IDAP REPORT

Property:	3 Edgar Street STRATHFIELD LOT 69 DP 12405 DA2022.21
Proposal:	Demolition of existing structures, construction of a two-storey dwelling house with a basement level, in-ground swimming pool and ancillary landscaping.
Applicant:	H Kim
Owner:	JW & MS Son
Date of lodgement:	16 February 2022
Notification period:	3 March 2022 – 18 March 2022
Submissions received:	Nil
Assessment officer:	J W Brown
Estimated cost of works:	\$1,215,500.00
Zoning:	R2-Low Density Residential - SLEP 2012
Heritage:	No
Flood affected:	No
Is a Clause 4.6 Variation Proposed:	N/A
RECOMMENDATION OF OFFICER:	Approval

Figure 11: Reduced first floor balcony

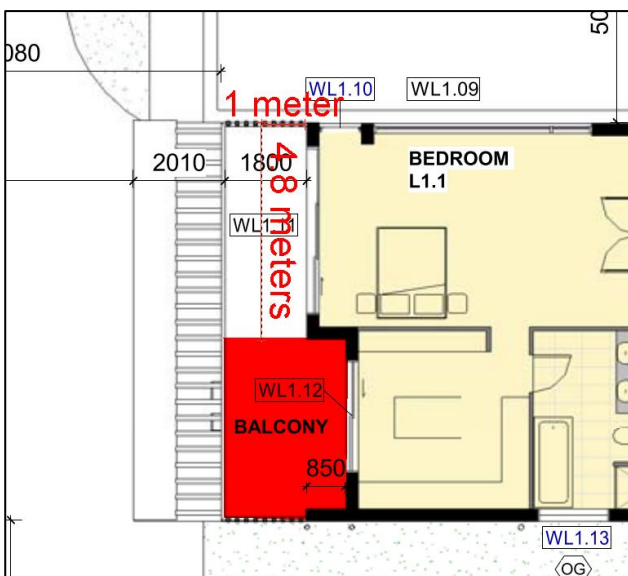
The first floor balcony facing the rear yard exceeds the required 1m by 2m requirement within the SCDP 2005. This large balcony has the potential for significant overlooking into adjoining neighbouring properties. Therefore, it will be conditioned that the balcony and roof above will have a maximum depth of 1m with a 4.8m length thereby deleting the part of the balcony outside the walk-in-wardrobe (figure 11). This will alleviate the potential of overlooking as well as lessening the bulk and scale of development and helping to reduce the height non-compliance discussed above.

Figure 12: Area of ground level (pale green) to be lowered

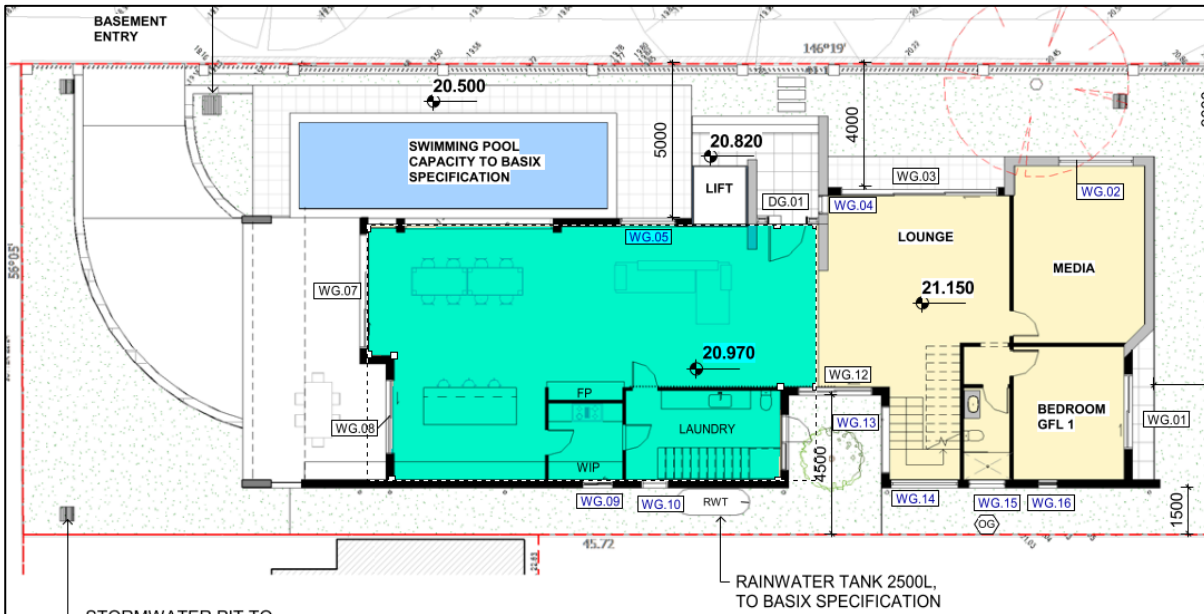
Basements are required to be kept to less than 1m above natural ground level to be considered a basement. Small sections of the northern end of the basement protrude more than 1m above existing ground level due to the slope of the site. It is recommended that a condition be added to drop the ground floor plate of the kitchen dining and lounge room including the walk-in-pantry and laundry (figure 12) by 200mm to RL20.77. This will make the basement compliant with both 1m control and the two storey development controls within SCDP 2005 and will reduce the bulk of the basement out of ground.
